**Request for Additional Information No. 227**

**U. S. EPR Standard Design Certification**

**Docket No. 52-020**

**SRP Section: 19 - Probabilistic Risk Assessment and Severe Accident Evaluation**

**Figure 19-288-1: Impact of Relative Cutoff Values on the CDF Results and Quantification Time**

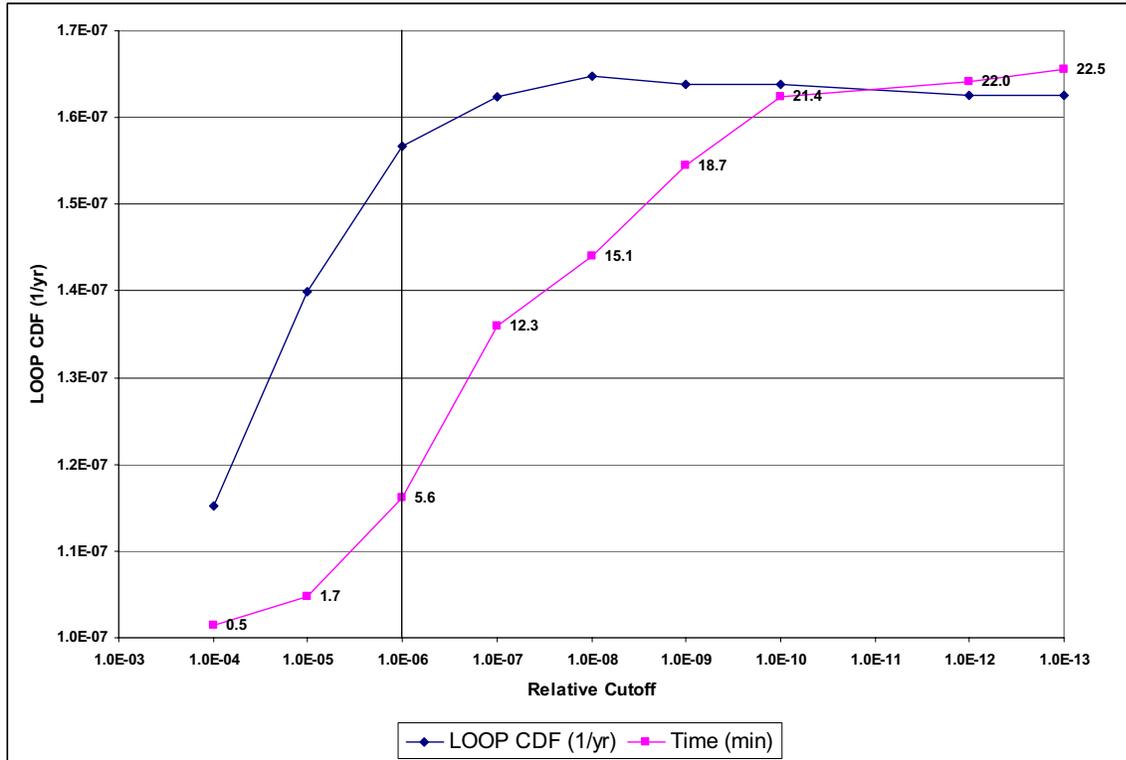
Page 19.1-45 of the FSAR states that “[t]he model is solved by using a 1E-20 truncation limit, and a 1E-6 relative truncation limit. The CDF quantification, for Level 1 at power, all events, resulted in over 73,000 cutsets.” The staff needs additional information on these truncation limits to determine that the reported CDF adequately represents the U.S. EPR design. Specifically, address the following topics and revise the FSAR as appropriate.

- a. Describe the evaluation performed to determine that these truncation limits were appropriate (e.g., results had converged).
- b. Define the “relative truncation limit.”
- c. Justify the 1E-6 relative limit given the high level of redundancy in the U.S. EPR design, which would yield many low-frequency cutsets with different combinations of independent failures.

A simplified evaluation was performed with different cutoff points, to evaluate cutoff (truncation limit) values where the quantification results would have stabilized, while still allowing a reasonable time for quantification (the current probabilistic risk assessment (PRA) Level 2 quantification requires over 5 days). An example of this evaluation for a loss of offsite power (LOOP) event tree is shown in Table 19-288-1, and, for relative cutoff values, illustrated in Figure 19-288-1. In this example, core damage frequency (CDF) cutsets are not post-processed or minimized.

As shown in the table and the figure, running time is sensitive to both an absolute and a relative cutoff, while the results are more sensitive to relative cutoff values. Figure 19-288-1 illustrates that the results would stabilize around a 1E-6 cutoff value, and that further lowering of this value would not significantly change the results, though it would increase the time for calculation.

As discussed in the Response to Question 19-288a, Figure 19-288-1 illustrates that the results would stabilize around a 1E-6 cutoff value, and that further lowering of this value would not significantly change the results, though it would significantly increase processing time, making more complex quantifications unpractical. Based on this, the relative cutoff of 1E-6 was selected as an acceptable compromise between results stabilization and running time. Also as stated in the Response to Question 19-288a, this relative cutoff is close to an absolute cutoff of 1E-13, and should not have a significant impact on the results. While lower cutoff values could somewhat alter the results (still within the uncertainty limits), they are not likely to change the conclusions or insights from the probabilistic risk assessment (PRA) model.

**Figure 19-297-1: Fault tree “EFW INV”: Failure of EFW Inventory Including Pressure Boundary Failure**

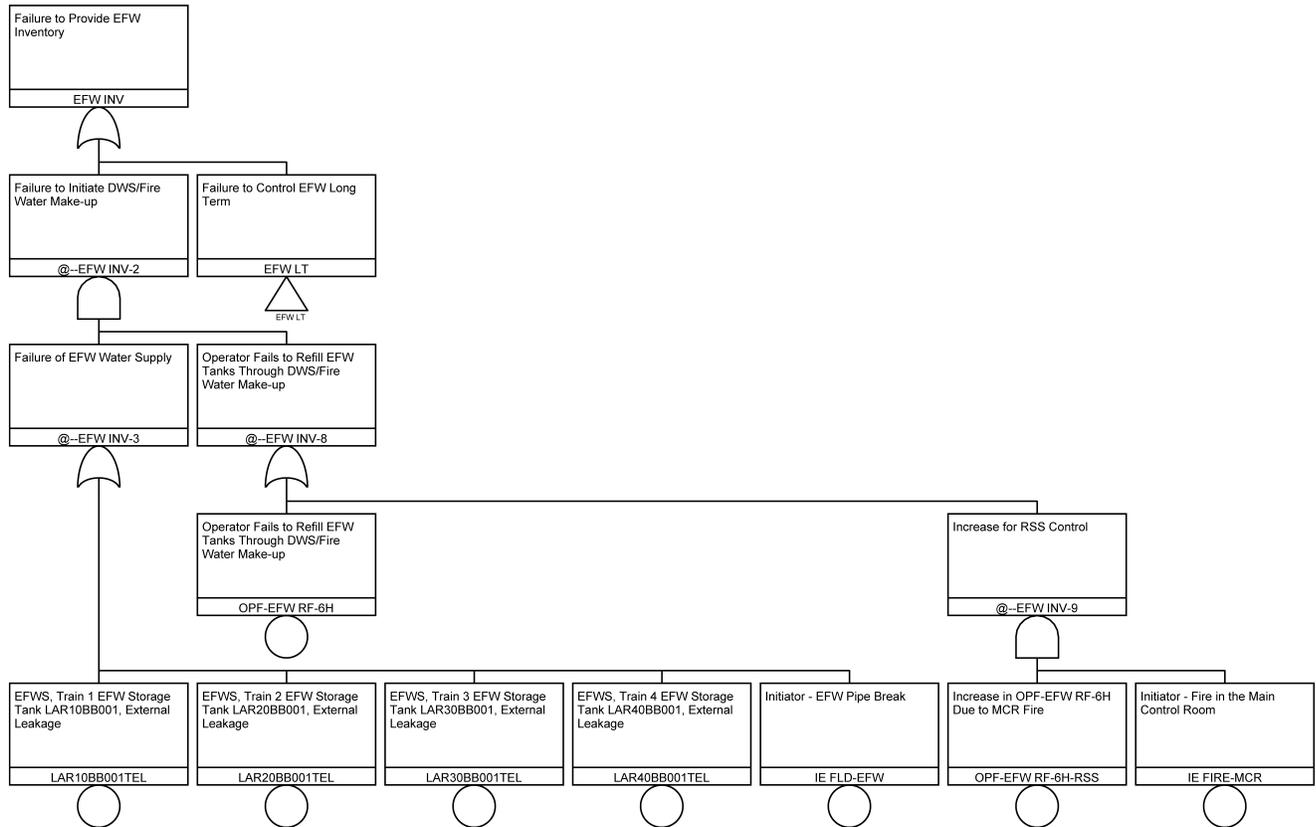
(Follow-up to Question 19-274) For the sensitivity study performed in response to Question 19-274, it is unclear how the logic representing “[i]f one (or more) EFW[S] trains are unavailable” and “[i]f one EFW[S] train is unavailable due to a pressure boundary failure” was developed. Provide revised EFWS fault trees that show the changes made, as well as any other relevant PRA changes, so that the staff can understand the effect on the model. If the eventual PRA update will be implemented differently from the sensitivity study, discuss how it will be implemented.

The fault trees that model the failure of the EFWS due to insufficient inventory for the sensitivity study performed in response to RAI 197, Question 19-274 are shown in Figures 19-297-1 and 19-297-2.

The fault tree shown in Figure 19-297-1 is the input to the function event “EFW INV”. That function event replaces the existing header “EFW PBF”, which currently represents EFW pressure boundary failure only. It represents the failure of the EFWS to provide sufficient inventory to support secondary cooling for 24 hours.

The top gate is an OR gate between the two cases (with or without pressure boundary failure). The branch that represents the case where a pressure boundary fails is shown in Figure 19-297-1. The case where train unavailability requires tank interconnection is shown in Figure 19-297-1 as a transfer to the “EFW LT” fault tree, which is illustrated in Figure 19-297-2.

- OPF-EFW RF-6H (Figure 19-297-1) is used in the case of a pressure boundary failure to represent the failure to refill one of the intact storage pools.
- OPF-EFW-6H (Figure 19-297-2) is used in the case where one EFWS train is not available for a reason other than pressure boundary failure. It represents the failure to manually open the suction cross-connect valves.
